**CITY OF MERIDIAN
FINDINGS OF FACT, CONCLUSIONS OF LAW
AND DECISION & ORDER**

In the Matter of the Request for Preliminary Plat Consisting of 20 Single-Family Residential Lots and 4 Common Lots on 3.57 Acres of Land in the R-8 Zoning District, by Kent Brown.

Case No(s). H-2022-0006

SUBJECT: PP - H-2022-0006
Jump Creek South Preliminary Plat

B. "Proposed" Jump Creek South Preliminary Plat (date: 9/24/2021)

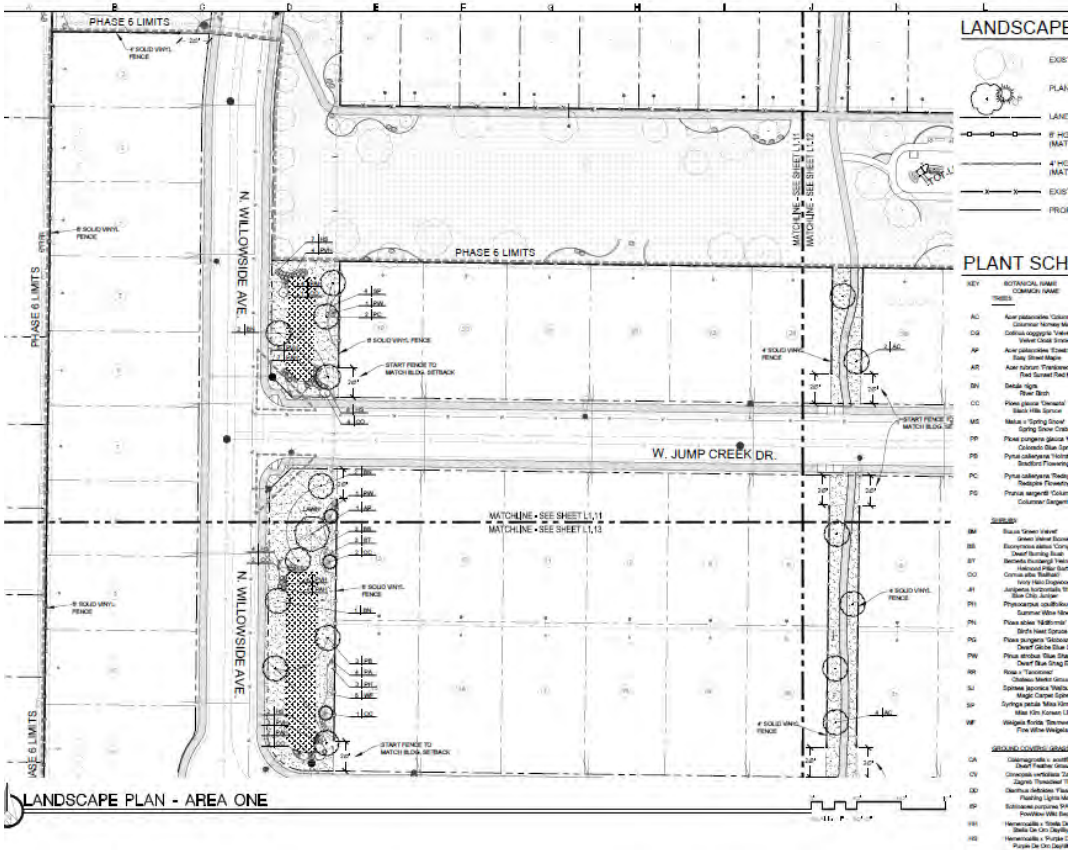
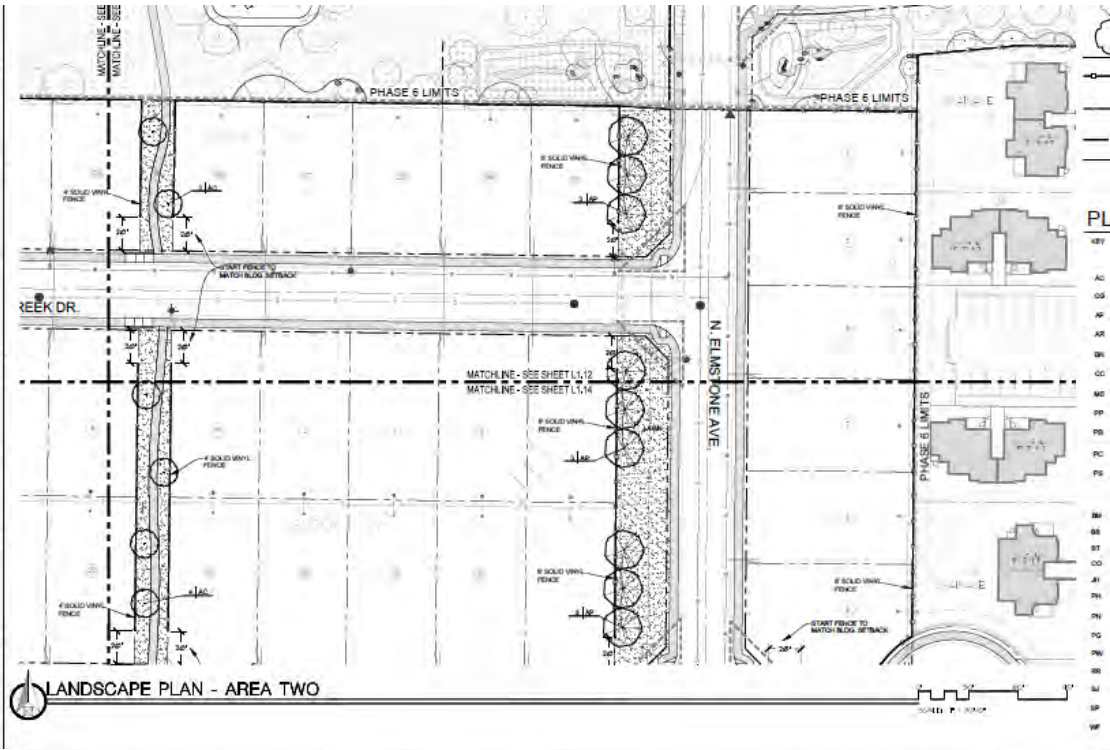
1. The Preliminary Plat included in Section VI, is approved with the following revisions:
 - a. Add date to the plat.
 - b. Revise Preliminary Plat name to read “Jump Creek South Subdivision.

C. Proposed Landscape Plan (Date: November 11/2/2020)

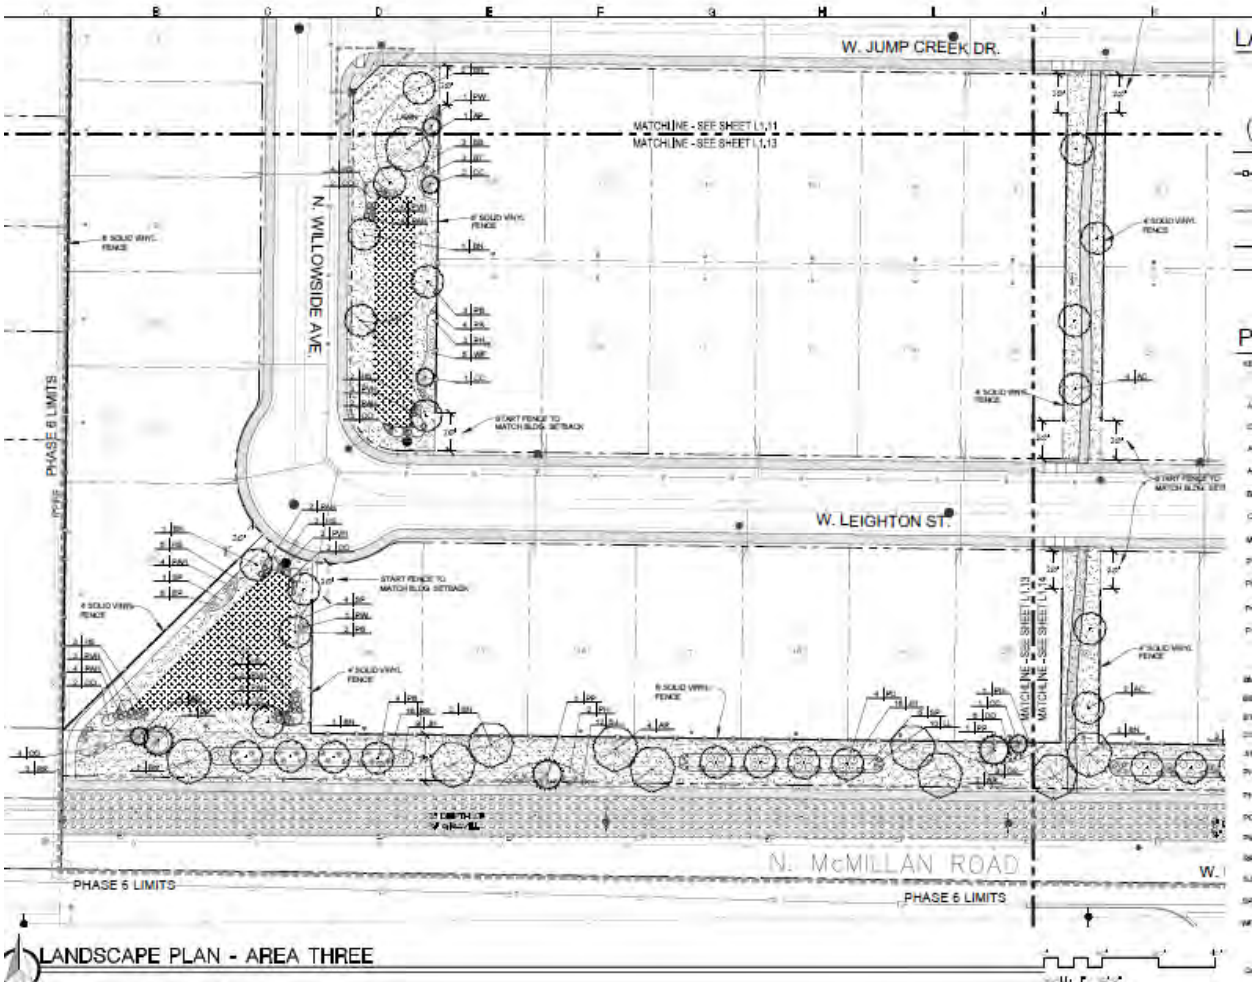
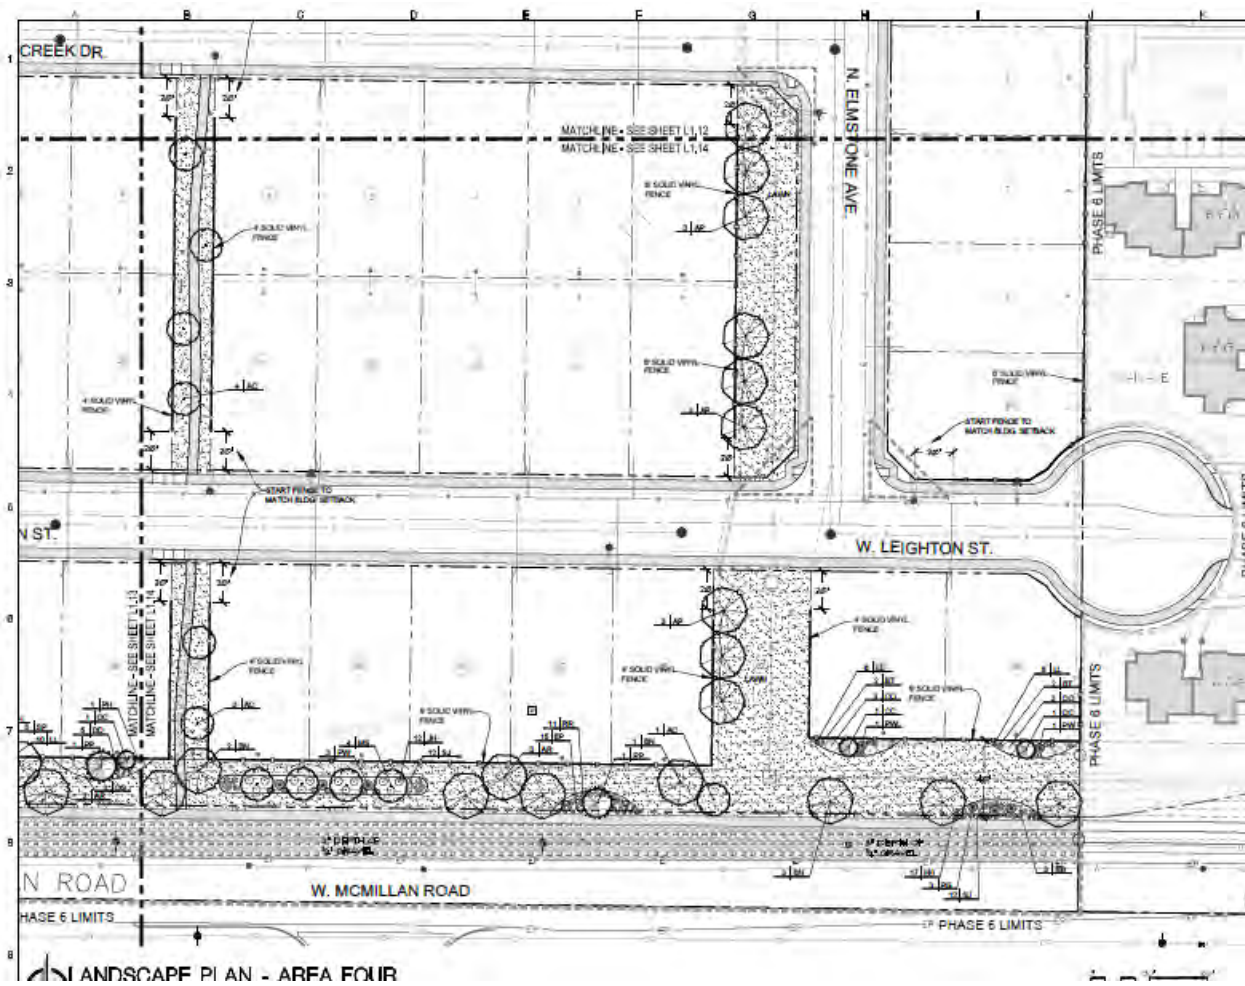
The landscape plan does not indicate whether there are healthy existing trees meeting the preservation requirements on the property. With the submittal of the final plat the applicant should submit a revised landscape plan that details any mitigation plan outlined by the developer and the City Arborist.

2. The Landscape Plan included in Section VI, dated 11/2/2020, is approved with the addition that the landscape plan shall indicate whether there are healthy existing trees meeting the preservation requirements on the property.
